AUBURN HILLS 15TH ADDITION WICHITA, SEDGWICK COUNTY, KANSAS

RE: SUB 2003-122 -- One-Step Final Plat of Auburn Hills 15th Addition

CASE NUMBER: SUB 2003-122 -- AUBURN HILLS 15TH ADDITION

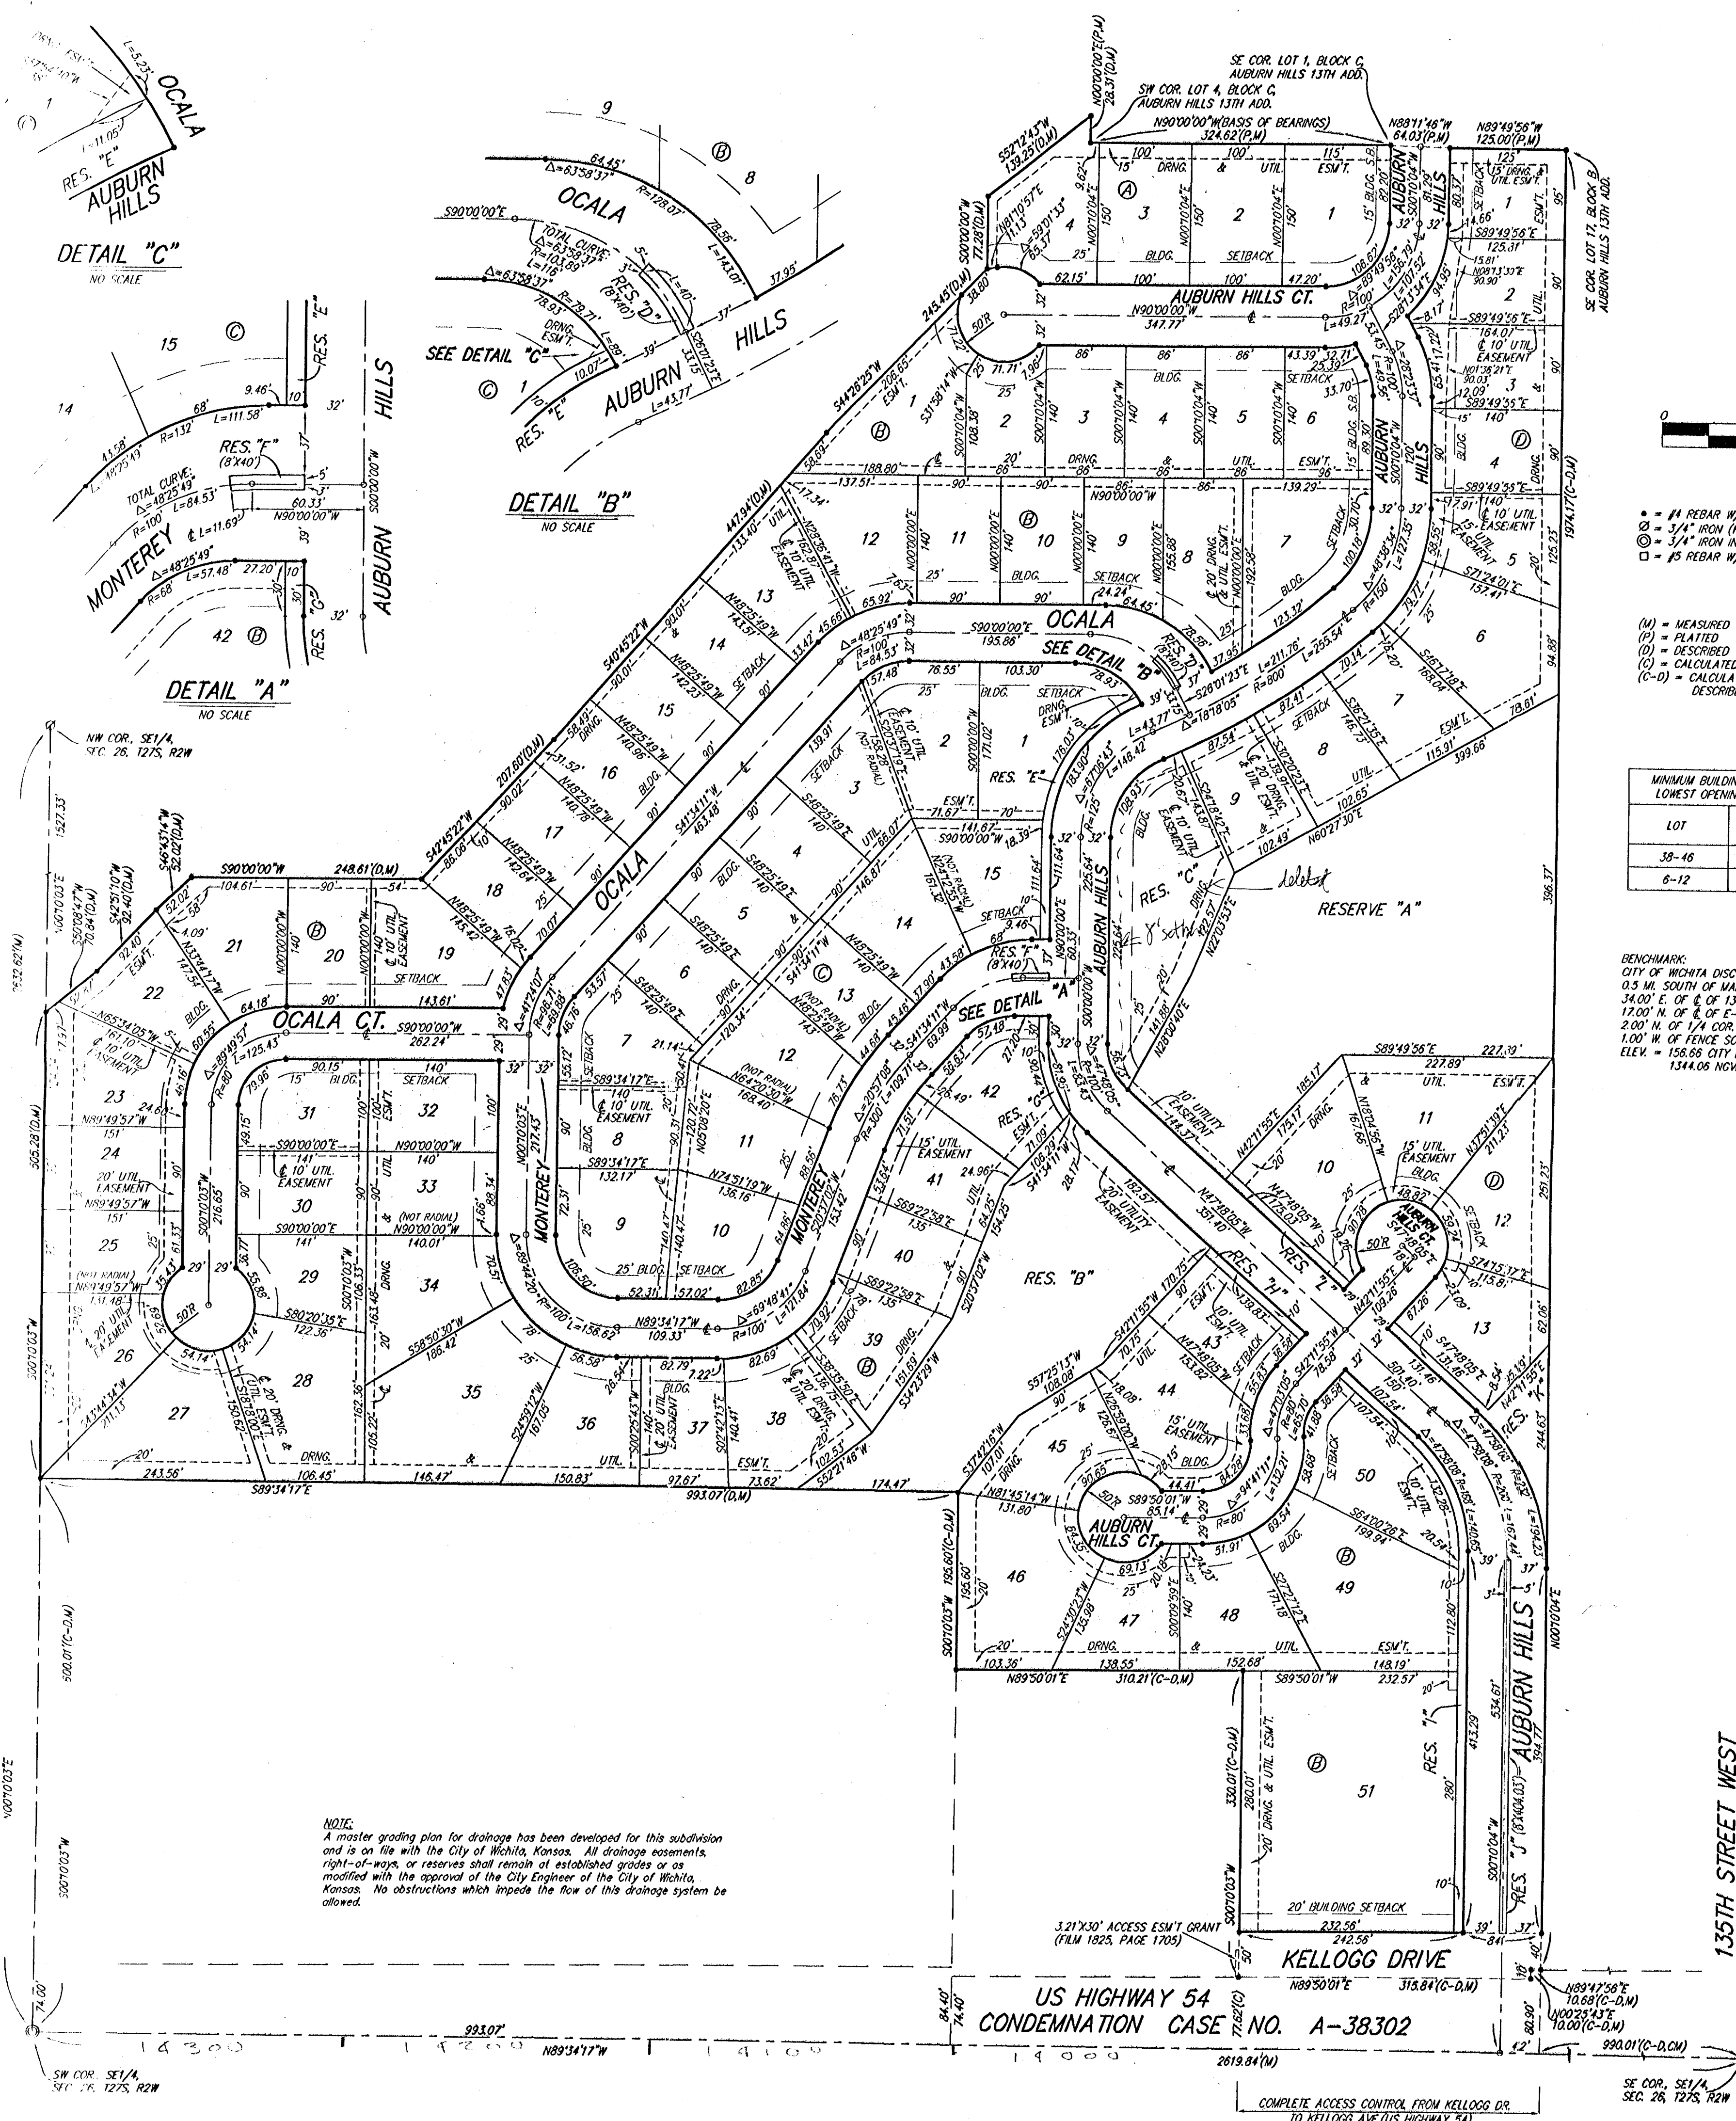
- A. This plat will be subject to approval of the associated zone change and any related conditions of such a change. Prior to this plat being considered by MAPC, the zone change will need to be approved. In the alternative, a restrictive covenant shall be submitted limiting this portion of the site to uses permitted in the SF-5 zoning district.

- D. City Engineering needs to comment on the status of the applicant's drainage plan. City Engineering requests additional information.
- E. The plat proposes a full movement intersection on Kellogg at a quarter-mile point on Kellogg. Traffic Engineering has advised that the City has worked with KDOT on an access management plan for the Kellogg Freeway that allows only signalized full movement intersections every half mile. The developer will need to obtain KDOT's approval for connection to Kellogg prior to development.

- F. The applicant is advised that the right-of-way width of Dogleg Cir may be revised to the 58-ft standard for cul-de-sac streets.
- G. The Applicant shall guarantee the paving of the proposed streets. The guarantee shall also provide for sidewalks on at least one side of all through, non cul-de-sac streets.

- H. As noted in the platlor's text, the applicant intends to restrict the utilities to easements on Reserves A and B and therefore such easements should be platted in these reserves.

- M. The blocks need to be renumbered (dividing Block A into two blocks) as the perimeter of the blocks should be bounded by streets. Block D should be encompassed within Block A.

- N. GIS needs to comment on the plat's street names. *The will be requesting that Dogleg in the adjacent plat to the north be revised to Auburn Hills by affidavit. The northernmost cul-de-sac shall be denoted as "Ct". Cross St. shall be assigned two new street names.*

- P. For any lots with existing tree rows that may be impacted by the installation of utilities, it is recommended that 30-ft utility easements be platted in order to allow for the installation of the utilities without damage to such tree rows.
